Metro Central Joint Development Assessment Panel Agenda

8.1 Property Location: Lot 75 (No. 72) Walter Road East (cnr Marion Street), Bassendean
 Development Description: Convenience Store Providing for the Sale of Fuel and Convenience Goods (Vibe)
 Applicant: Planning Solutions
 Owner: K. & W. Sales & Distribution Pty Ltd
 Responsible Authority: Town of Bassendean
 DAP File No: DAP/18/01473

Property Location:	Lot 75 (No. 72) Walter Road East (cnr Marion Street), Bassendean
Development Description:	Convenience Store Providing for the Sale of Fuel and Convenience Goods (Vibe)
DAP Name:	Metro Central JDAP
Applicant:	Planning Solutions
Owner:	K. & W. Sales & Distribution Pty Ltd
Value of Development:	\$2 million
LG Reference:	2018-088
Responsible Authority:	Town of Bassendean
Authorising Officer:	Christian Buttle – Senior Planning Officer
DAP File No:	DAP/18/01473
Report Due Date:	19 October 2018
Application Received Date:	3 August 2018
Application Process Days:	7 5 days
Attachment(s):	<ol style="list-style-type: none">1. Applicant's Development Application Report incorporating:<ul style="list-style-type: none">• Aerial photo showing development site in context of surrounding localit

PRINCIPAL AUTHOR:	MICHAEL UTTING
PRINCIPAL CLIENT:	VIBE PETROLEUM
PROJECT TITLE:	LOT 75 EDEN HILL PROPOSED CONVENIENCE STORE AND PETROL FILLING AREA
SCALE:	1:200
CODE:	DA
DRAWING TITLE.:	SITE PLAN
DRAWING NO.:	A01
SHEET	01

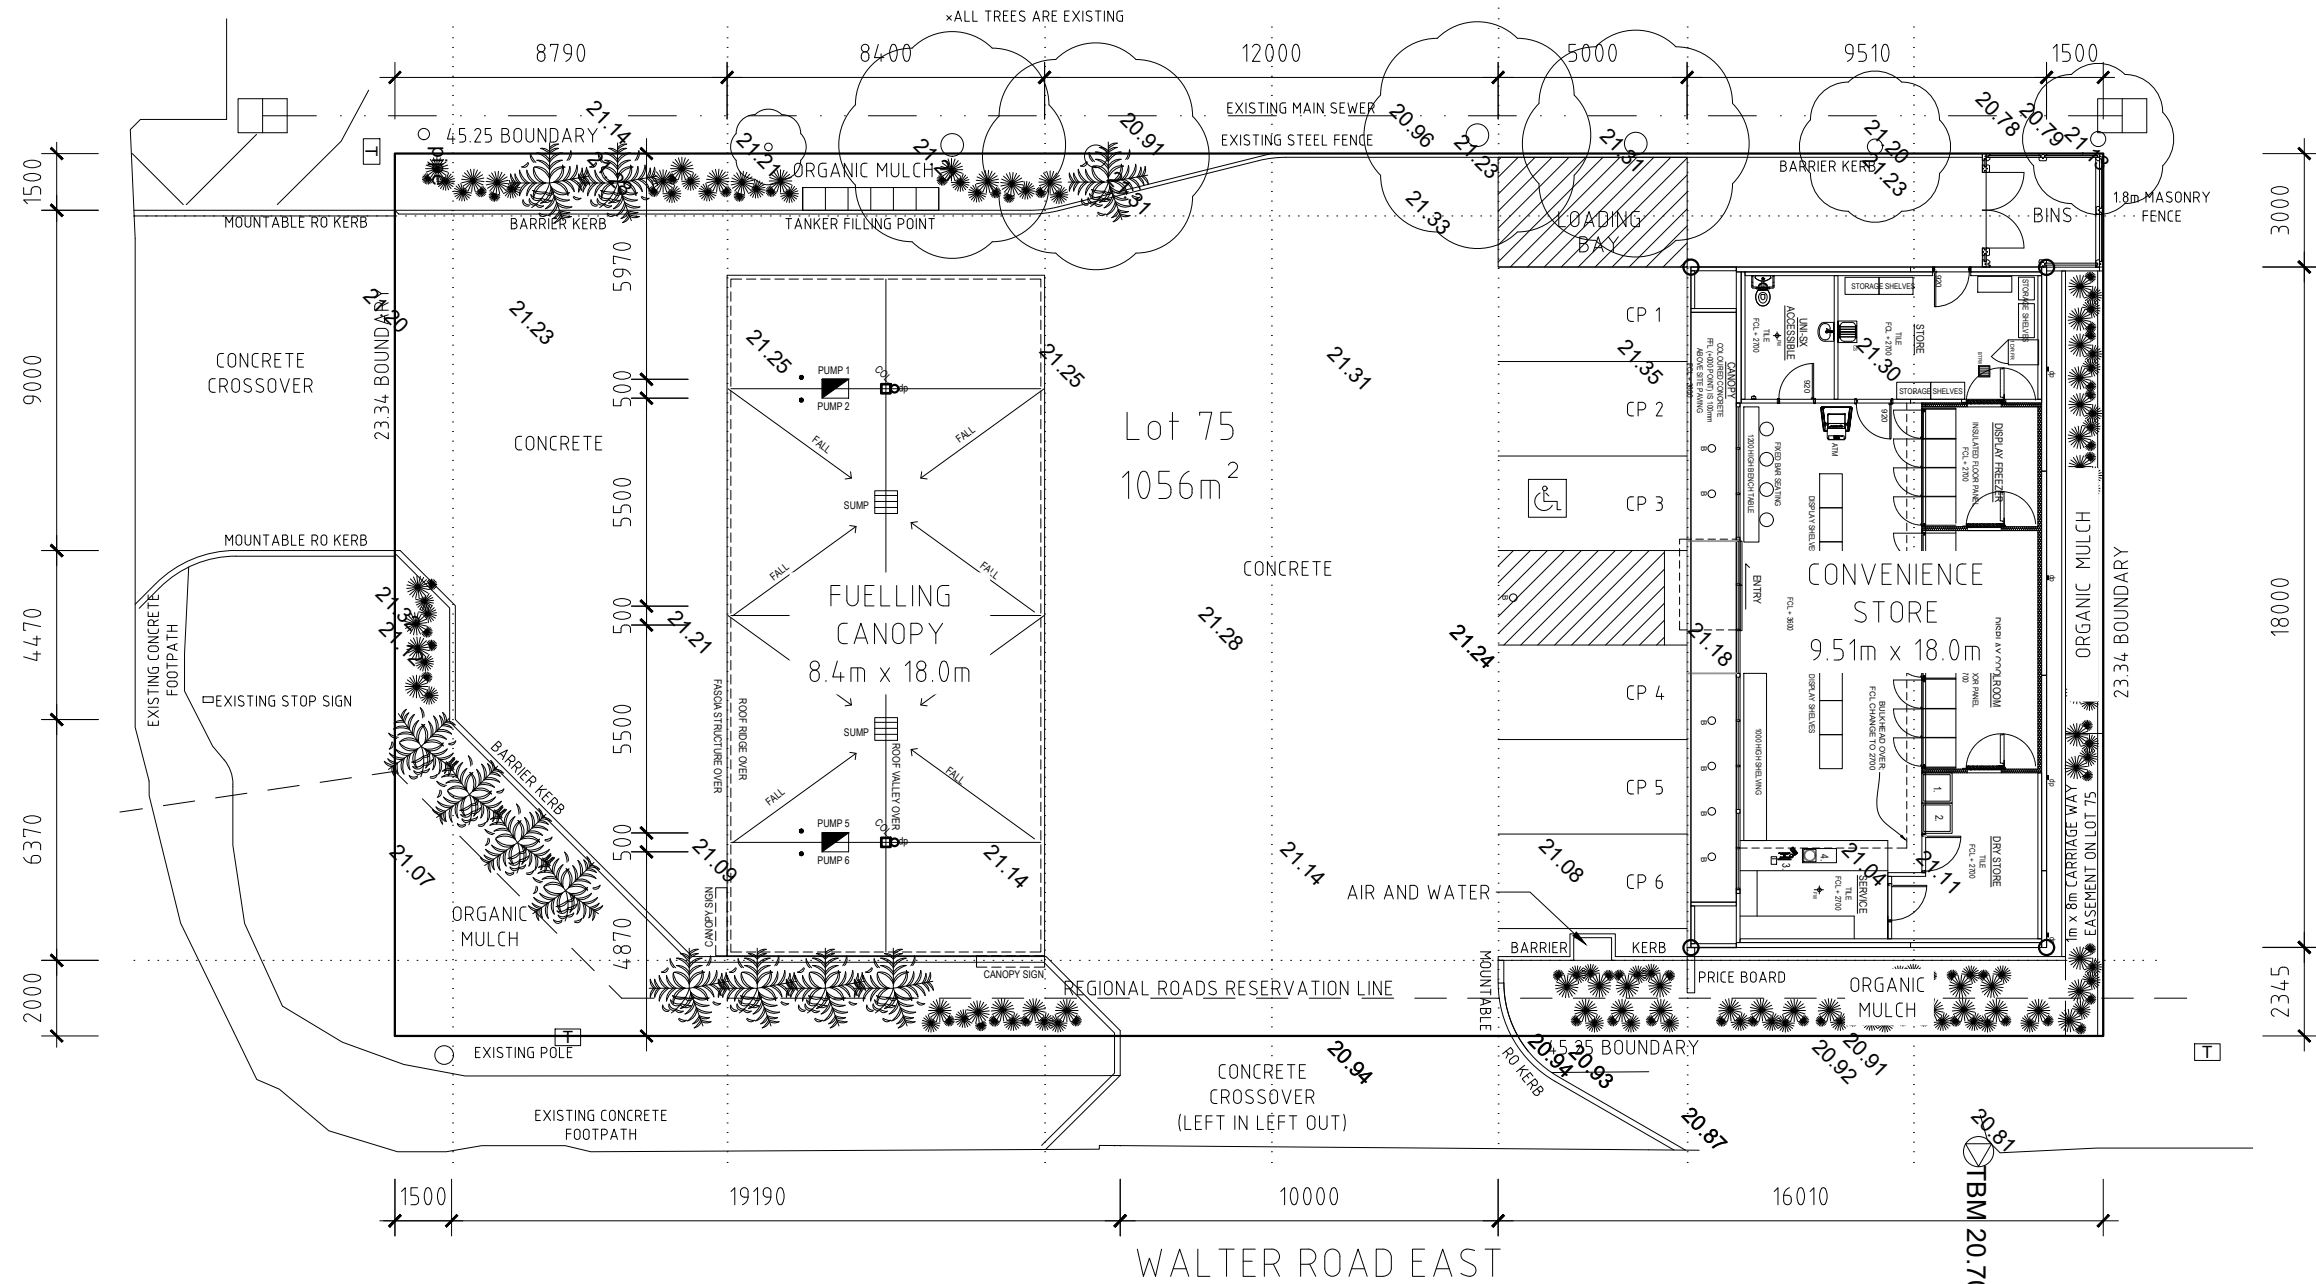
7. The width of car parking bays immediately forward of the proposed convenience store being non-compliant with the 2.6m minimum specified within Australian Standard AS 2890.1 (Off-street car parking) for the kind of development that has been proposed;

13. The width of landscaping along the Walter Road East frontage of the proposed development being less than that specified by Town of Bassendean Local Planning Policy No. 7 – Local Shopping Design Guidelines;

14. The proposed building setbacks to the Walter Road East frontage of the development site are considered to be unacceptable, having regard to the unsatisfactory urban design outcome that results from the blank building façade facing this street. As proposed, the compatibility of the development with its setting in terms of its orientation and appearance is not acceptable, contrary to clause 67(m) of the Planning and Development (Local Planning Schemes) Regulations 2015;

Car Parking – Dimension of Bays - Customers	2.6m minimum bay width prescribed by AS2890.1 for convenience store customer bays.	2.5m bay width proposed.	No Customer car bays for convenience store are under width. See further comment after table.
Bowser Bay – Dimensions	2.9m minimum bay width prescribed by AS2890.1 (i.e. 2.9 x 2 = 5.8m width required between obstructions associated with bowzers).	5.3m width provided between obstructions associated with bowzers.	No See further comment after table.
Commercial Vehicle – Dimensions of Service Bay	3.5m minimum bay width prescribed by AS2890.2.	3.0m service bay width proposed.	No See further comment after table.
Service Vehicle Access – Petrol Tankers (Within the development site)	AS 2890.2 states that design should be prepared to accommodate standard 19m long petrol tankers. (Vehicle Class – Articulated Vehicle)	Design based upon a non-standard 15m tanker length with no justification provided for such design basis. (Unknown Vehicle Class which is not referenced in relevant Australian Standard)	No Site cannot be serviced by a standard petrol tanker. See further comment after table.

Vehicle Movement Through Site	Safe and coordinated vehicle movement through site.	The design allows vehicles to enter the site from either Marion St or Walter Rd East and to traverse the site in opposing directions.	No Having regard to site constraints, traffic movement through the site should be limited to one way only. See further comment after table.

Figure 4: Fuel tanker turn path analysis

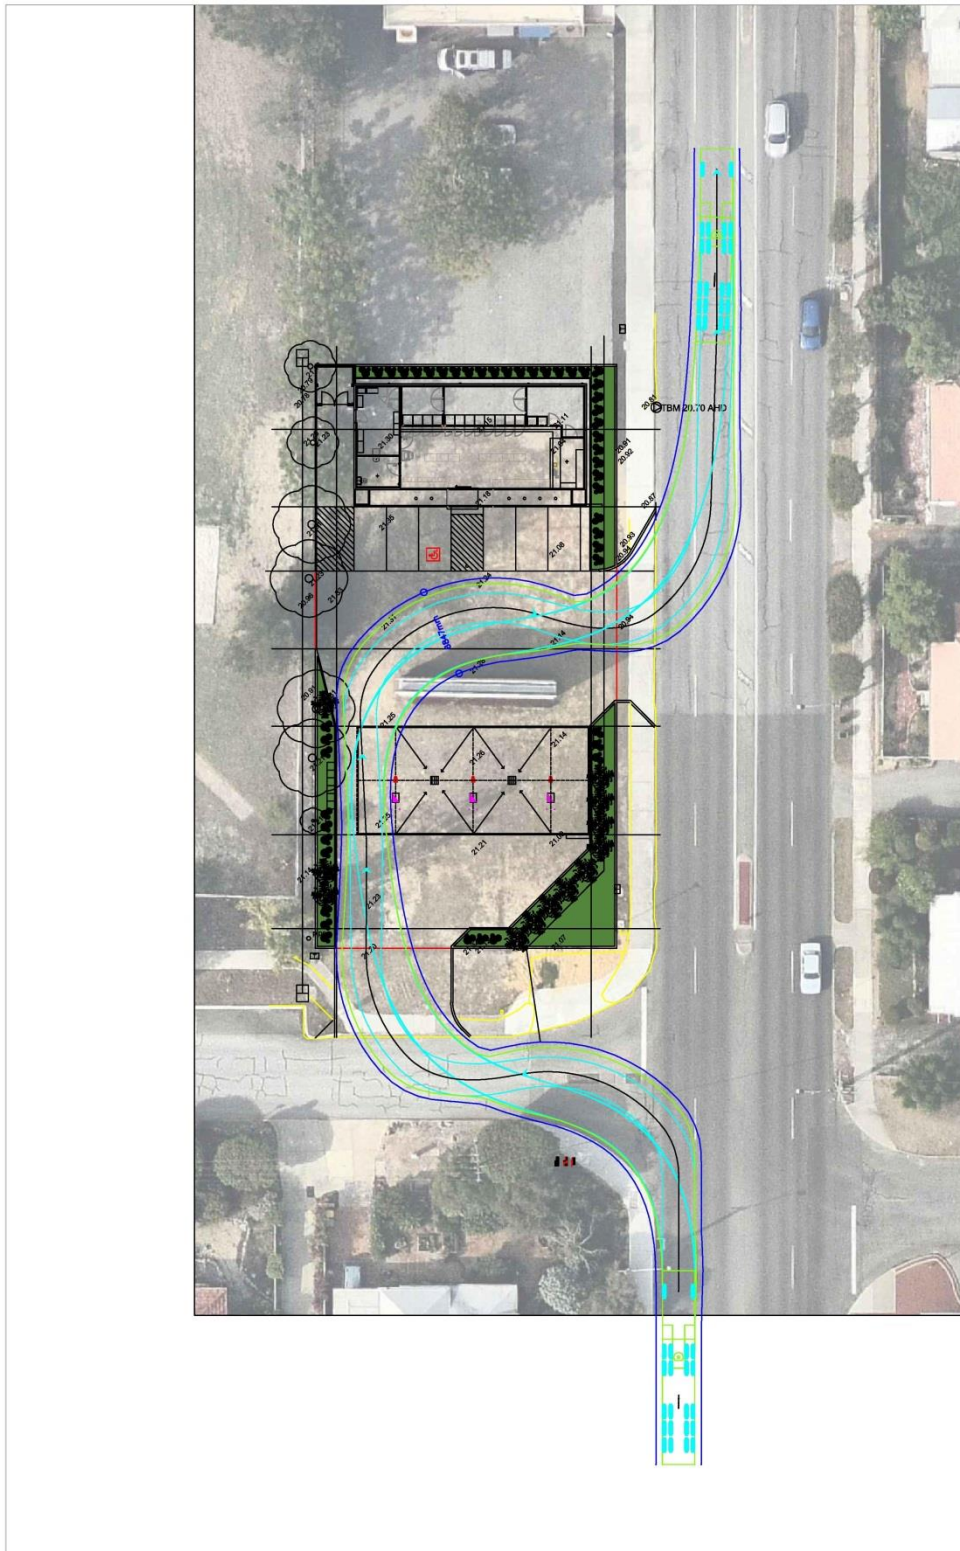
1. A recommendation that the submitted swept path analysis plans be verified / checked to the satisfaction of the Town's engineering staff, having regard to the small size of the development site and the sharp turning movements which must be made to accommodate the 15m long petrol tankers referenced within the report;
2. The provision of a median treatment within the Walter Road East reservation to limit turning movements to left in left out only on Walter Road East; and
3. Signage associated with the development not interfering with sight lines, not distracting drivers and not having the potential to become confused with traffic signals or road signs.

The applicant has been asked to provide information / justification regarding the 15m length tanker referred to in application documentation, however no such information / justification has been provided and in the absence of this the facility should be designed to accommodate the industry standard service vehicle (i.e. 19m long tanker) as specified by Australian Standard AS2890.2 – Parking Facilities – Part 2: Off-street commercial vehicle facilities.

When approaching the development along Walter Road East (from the west), petrol tankers are unable to remain lane correct (i.e. they must use the entirety of the road), when turning into Marion Street. They must then use the entirety of the Marion Street road pavement up to the point where they enter the development site (and when entering the development site they must also utilise the entire width of the crossover on the Marion St frontage of the development site).

If a petrol tanker is arriving at the Marion St / Walter Rd East intersection at the same time that vehicles are attempting to exit Marion St onto Walter Rd East in a westerly direction, the petrol tanker must wait on Walter Rd East and allow vehicles on Marion Street to clear completely in order that it can make its (non-lane correct) approach to the entrance of the petrol station. However, while paused on Walter Rd East, a petrol tanker would be blocking the line of sight for vehicles wanting to exit onto Walter Rd East. The line of sight for such vehicles would be restricted beneath Approach Site Distance (ASD) requirements and below Safe Intersection Sight Distance Requirements (SISD) as specified within the Austroads Guide to Road Design.

The inability of a petrol tanker to remain lane correct when approaching the site along Marion St; the restriction on sight lines that would result if a petrol tanker needed to pause on Walter Rd East to allow traffic to clear Marion St and the inability of a standard 19m long petrol tanker to service the development are each unsatisfactory from a traffic safety perspective.
